CHANGE ORDER

Project: WATER TREATMENT PLANT FINISHED WATER AND BACKWASH PUMPING PROJECT

Subject **DEIC 01 – Pump Space Heater** DEIC No. **01**

Contract Document Reference **E106, E601, E602** Date: **03/30/2022**

PROCESS POWER PLAN - FIRST FLOOR

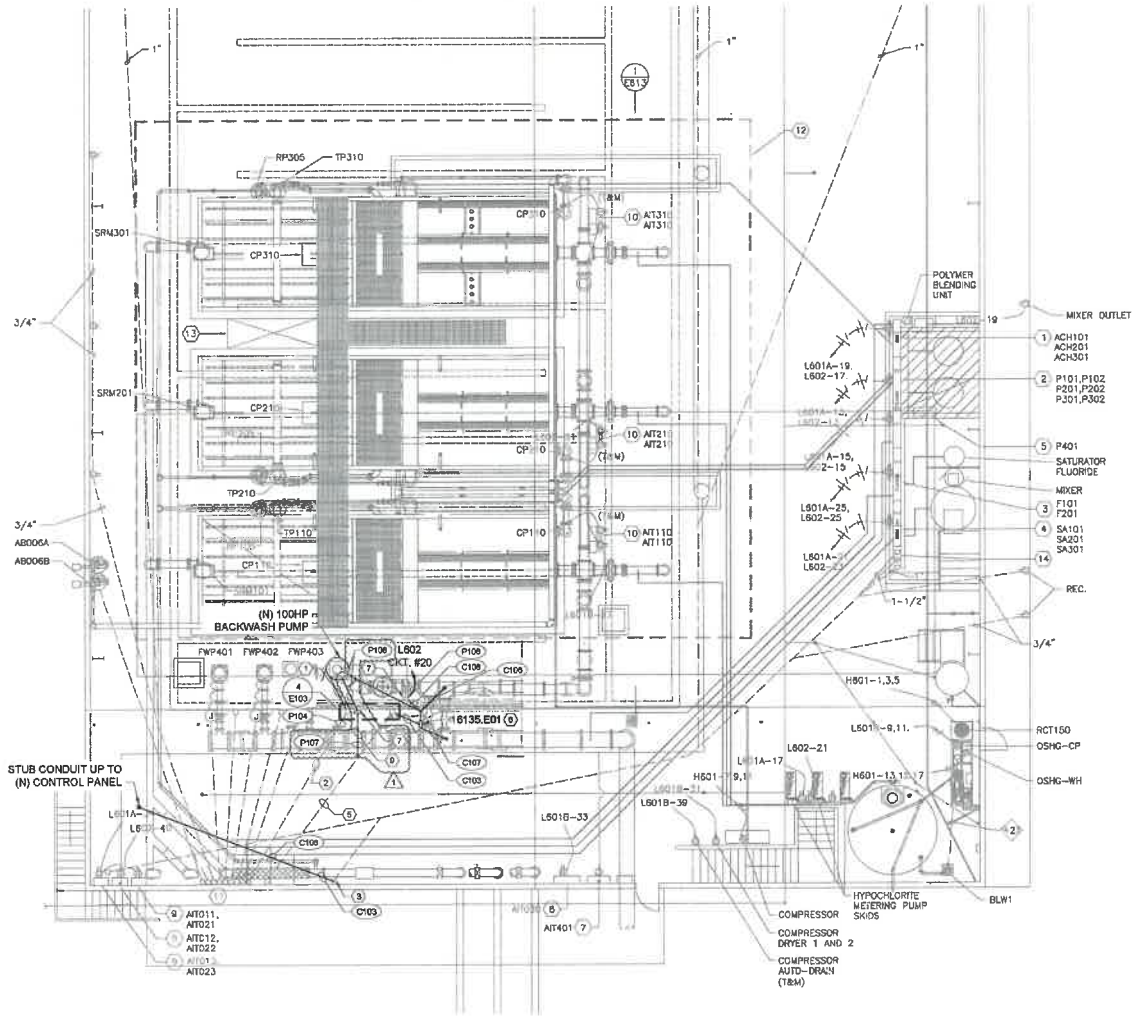
7. PROVIDE 120V CIRCUIT FROM (E) LP602 CIRCUIT 22 TO (N) MOTORIZED VALVE. UTILIZE (E) SPARE 20A, 1-POLE CIRCUIT BREAKER.
8. (N) CPT ENCLOSURE PROVIDED BY INTEGRATOR OF RECORD AND INSTALLED BY CONTRACTOR. PROVIDE STRUT SUPPORTS AS REQUIRED TO SUPPORT ENCLOSURE.

9. CONDUIT TO BE ROUTED OVERHEAD TO (N) CPT ENCLOSURE. PROVIDE STRUT SUPPORTS AS REQUIRED TO SECURITY CONDUIT.

1 SECOND FLOOR PROCESS POWER AND SIGNAL PLAN
SCALE: NTS

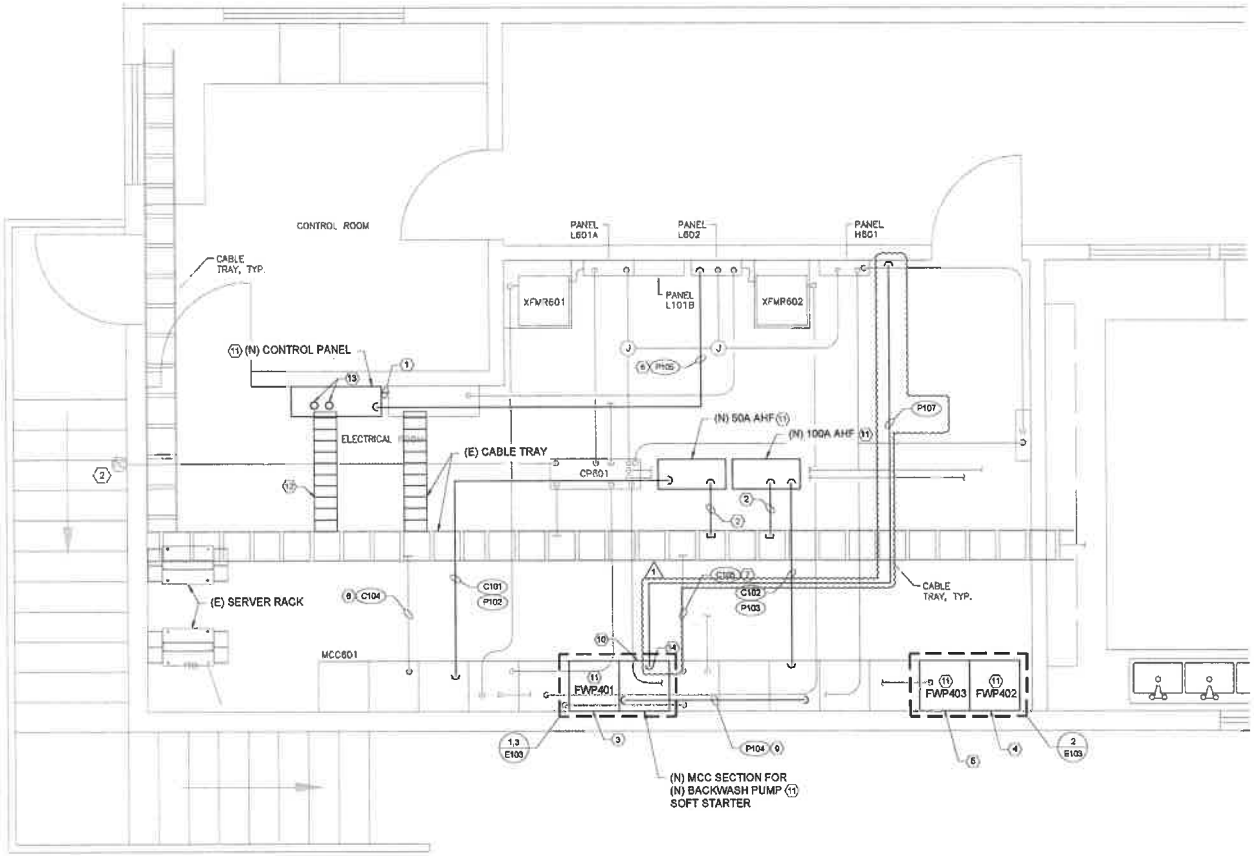
Spec 11352 called for a space heater to mitigate condensation where specified or recommended by the manufacturer. Within submittal 06, a space heater was included in the manufacturer's submittal, but the design did not account for the hardware and power supply for this. Please refer to the attached drawings to see power supply changes to accommodate the space heater.
